DARWIN CITY COUNCIL

TOWN PLANNING COMMITTEE

WEDNESDAY 3 JUNE 2009

10.1	Development Application Lot 1756 (25) Daly Street, Darwin 40 x 3 Bedroom Multiple Dwellings & Offices in a 12 Storey Building Including Car Parking in the Basement and Levels 1 to 3.....	6

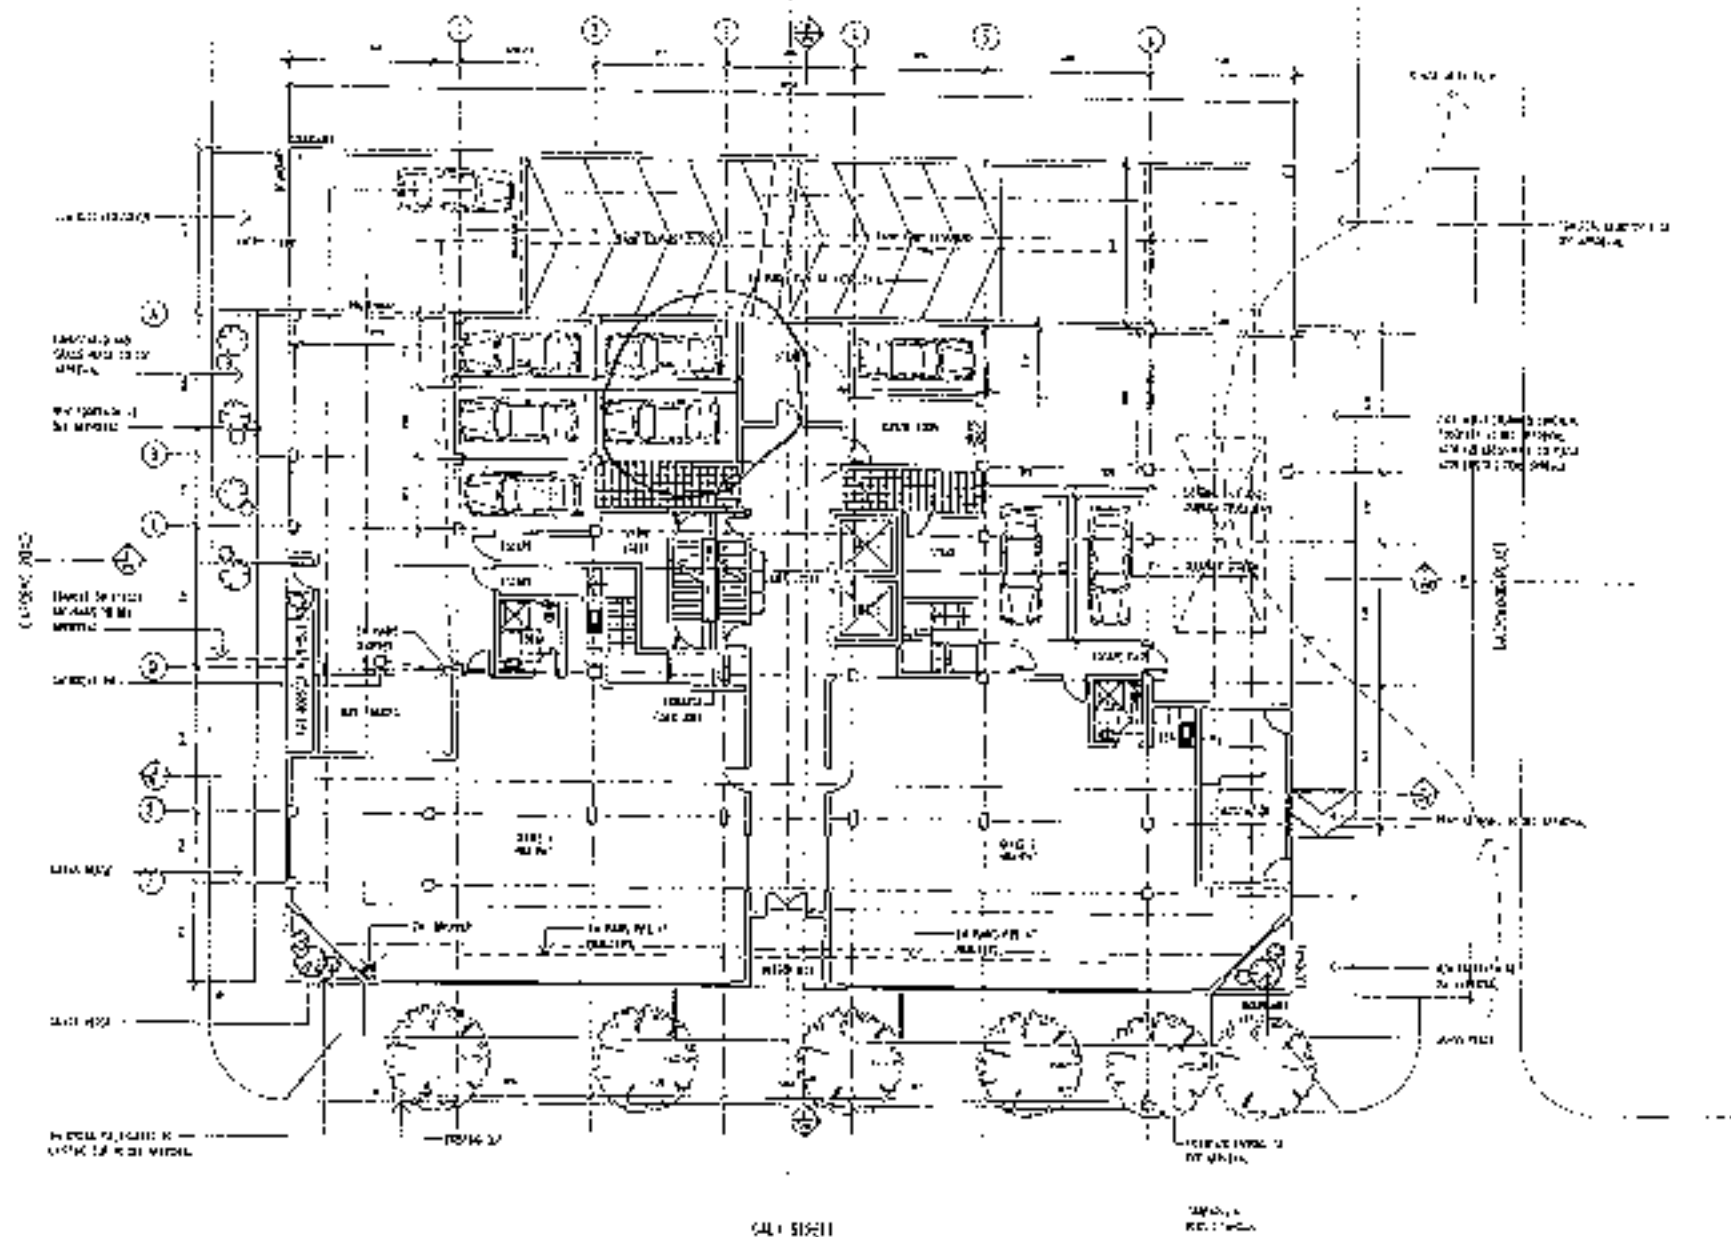
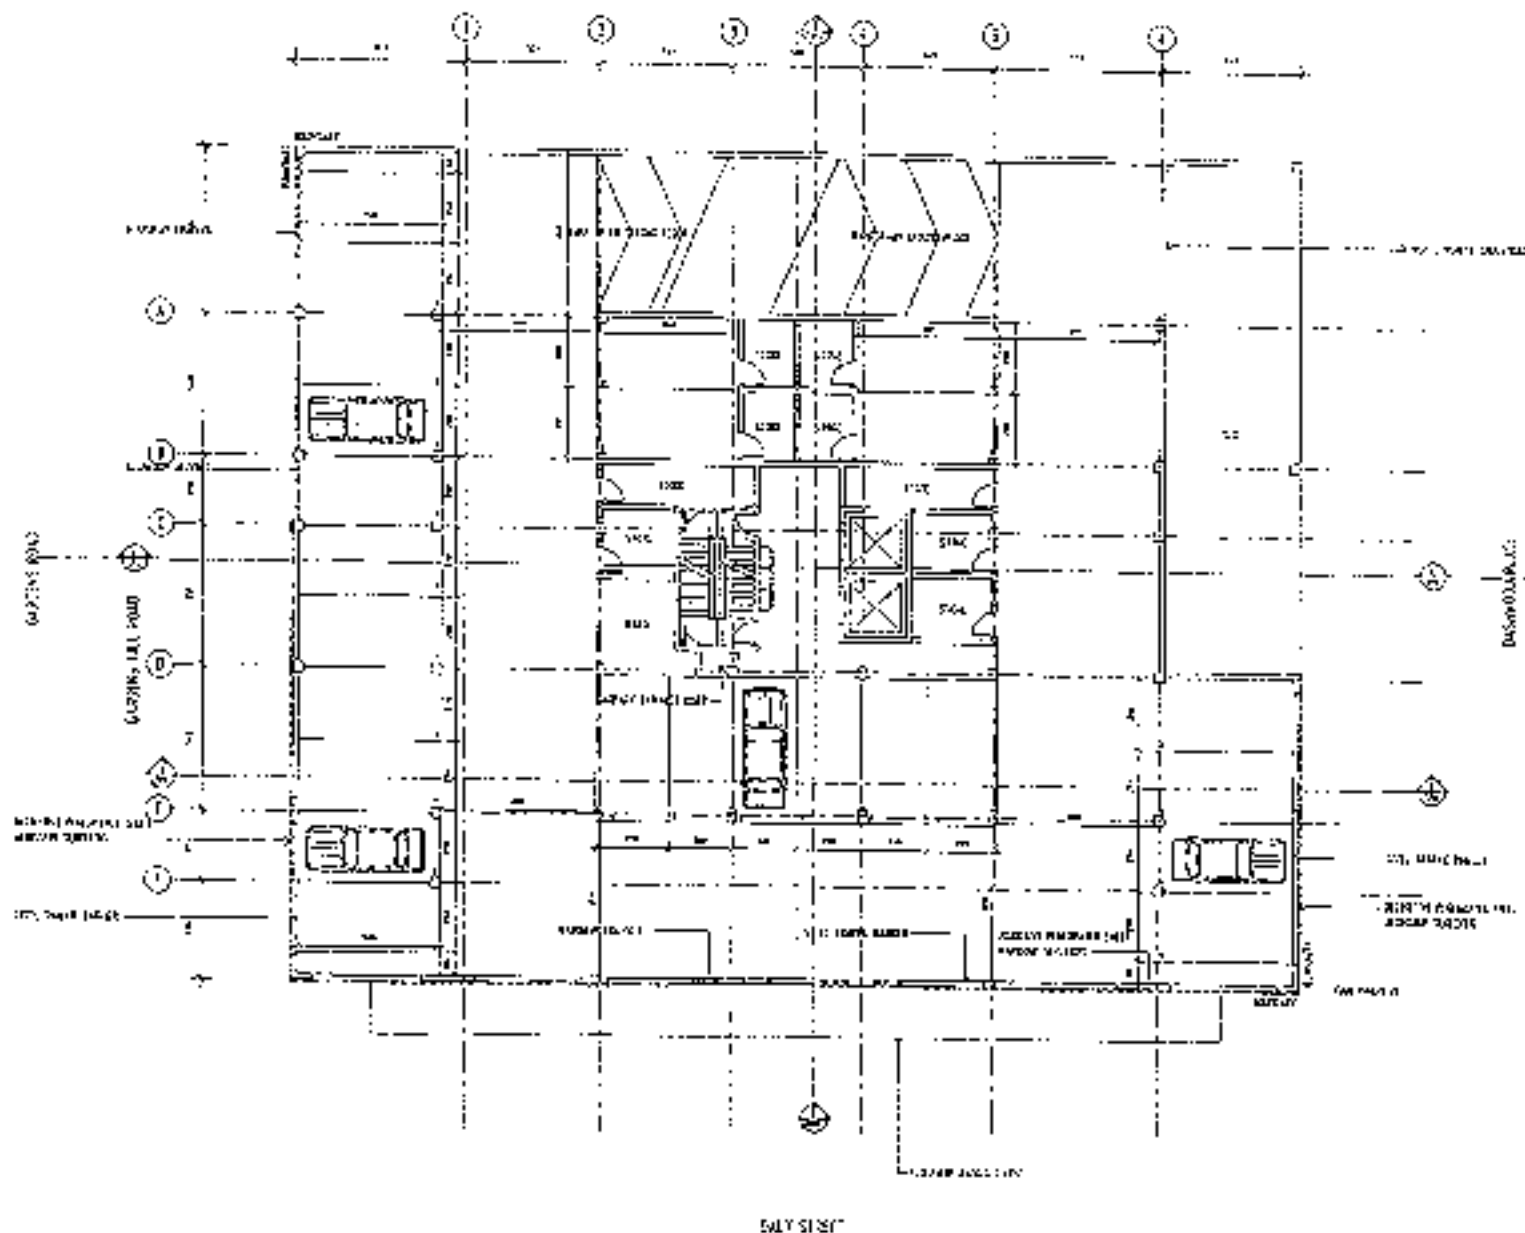
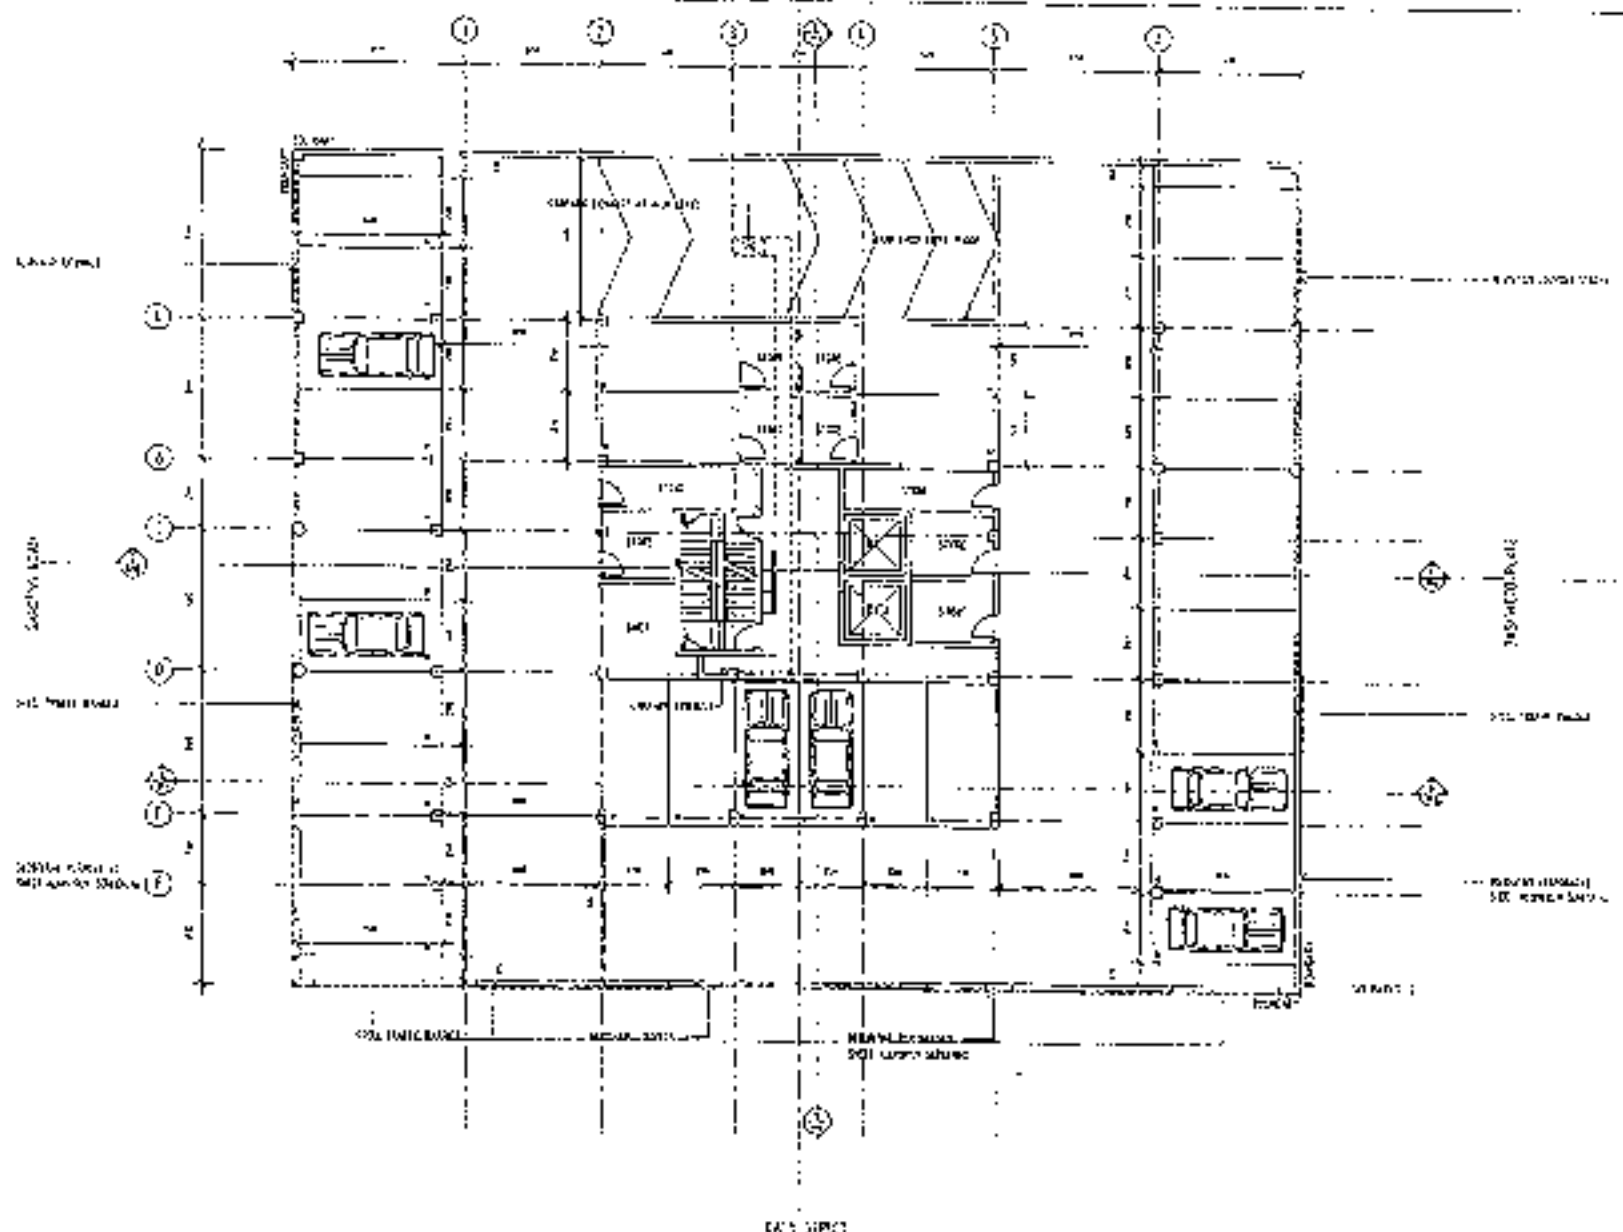
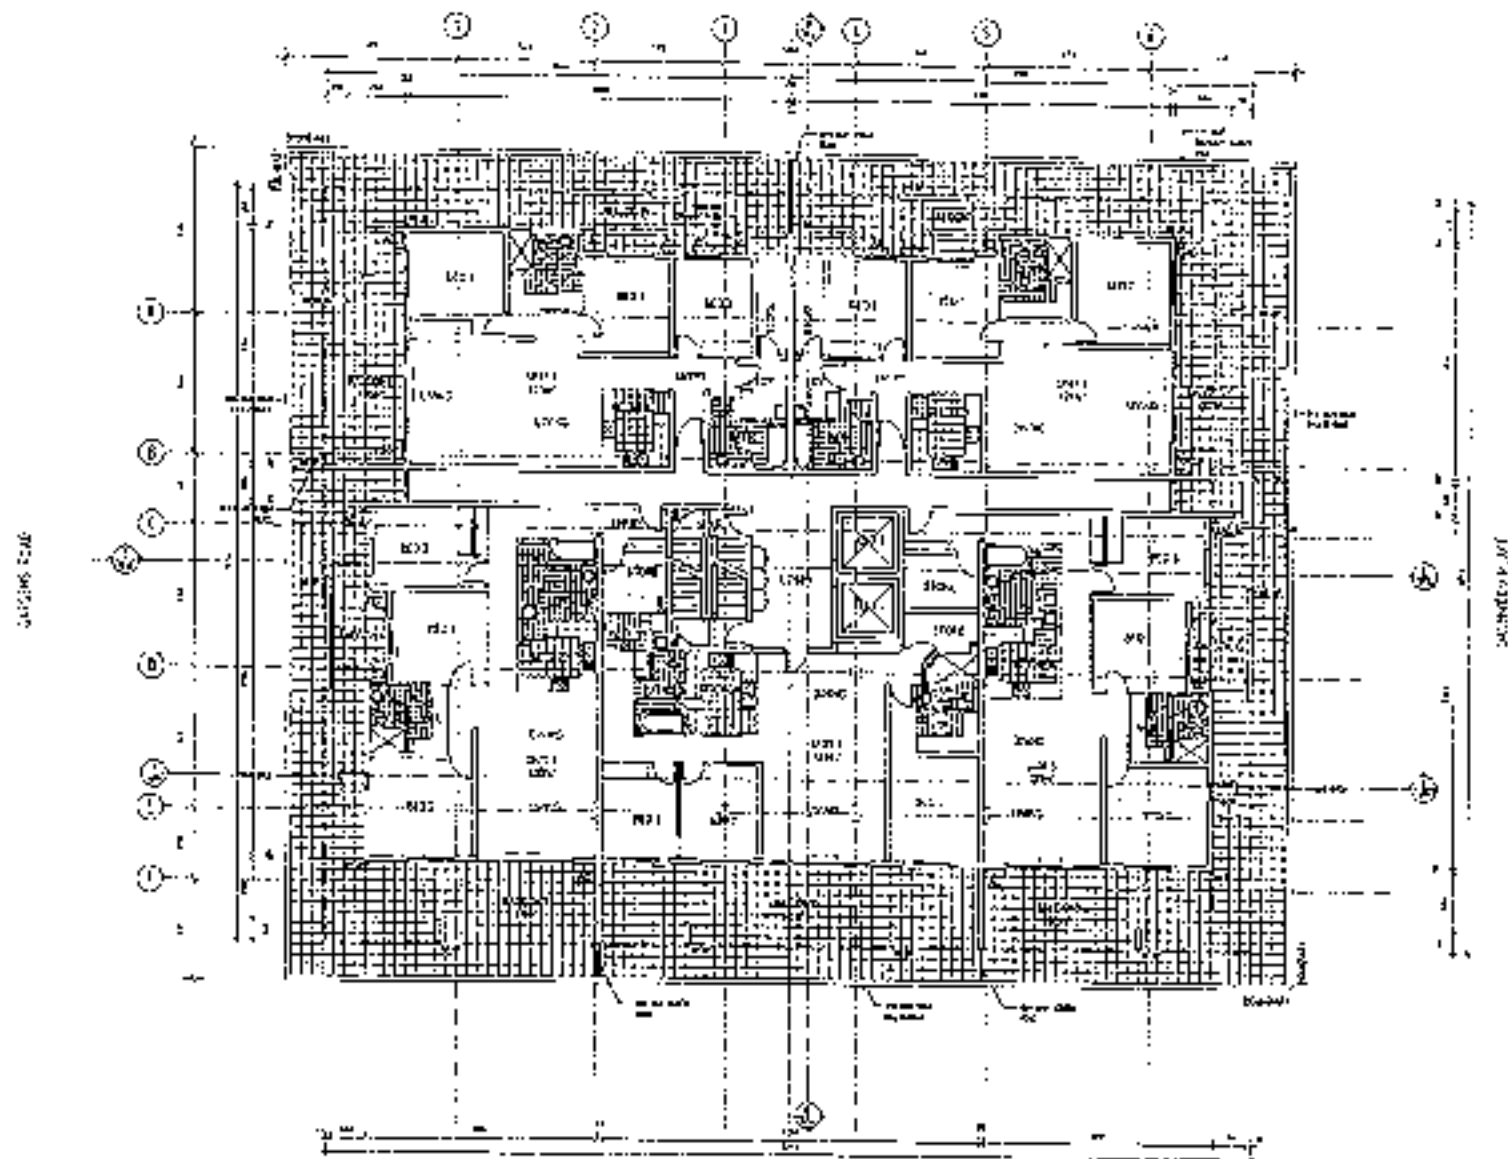
Footpath / Verge: The Ground Floor Plan includes landscaping and footpath works within Council's verge areas on Gardens Road, Dashwood Place and Daly Street.

but the plans do not indicate whether the path and trees already exist or are part of the proposal.

Waste Bin Storage: There is a waste bin room of approximate usable internal dimensions 4.0 x 2.6 metres shown on the ground floor of the submitted plans.

- i). **Council supports in principle the granting of a Development Permit provided the following issues are adequately addressed:**
 - a). **Council requests the Authority requires amended plans demonstrating on-site driver sightlines from the proposed Gardens Road and Dashwood Place car park exit ramps. Sightlines are to be integrated into the on-site design of the development so that drivers exiting the car parks can see pedestrians approaching the car park exit driveways and ramps. It is also requested that a condition be placed upon any development permit issued that no wall, fence or tree exceeding 0.6 metres in height be constructed or planted in front of the sight line.**

- b). **Council requests the Authority requires amended plans demonstrating waste management and waste bin storage facilities in accordance with Council's Waste Bin Policy (Policy No. 333 – as amended 26/02/08). This current proposal does not meet Council's requirements for the following reasons:**

- 1). A new footpath, approx. 1.2 metres wide, and a landscaped and grassed verge for Gardens Road.
- 2). A full width, approximately 2.5 metres wide, coloured concrete footpath for Dashwood Place, with a 1:20 cross fall to make it flush with the existing road surface. It is assumed that the cross fall is proposed to facilitate vehicle access to the loading bay.
- 3). An approximate 2 metre wide footpath and street trees are shown along the Daly Street frontage of the proposed building, but the plans do not indicate whether the path and trees already exist or are part of the proposal.

The applicant's plans include a 2.0 metre wide canopy over the Daly Street road reserve. The applicant should be advised that Council will not approve any balconies or blade walls overhanging Council's land.

"Notwithstanding the approved plans, the proposed footpath and landscaping works are subject to Council's approval and shall meet all Council's requirements to the satisfaction of the General Manager of Infrastructure, Darwin City Council and at no cost to Council."

"Notwithstanding the approved plans, any proposed awning is subject to Council approval and shall meet all Council's requirements to the satisfaction of the General Manager of Infrastructure, Darwin City Council and at no cost to Council."

- The Applicant be required to provide an assessment of the proposal's car parking plan by a qualified engineer to demonstrate that the layout satisfies the Australian Standards, guidelines and controls for car park layout and circulation.

- Sight lines shall be provided at crossovers to public streets to the satisfaction of the General Manager of Infrastructure, Darwin City Council. No wall, fence or tree exceeding 0.6 metres in height shall be constructed or planted in front of the sight line.
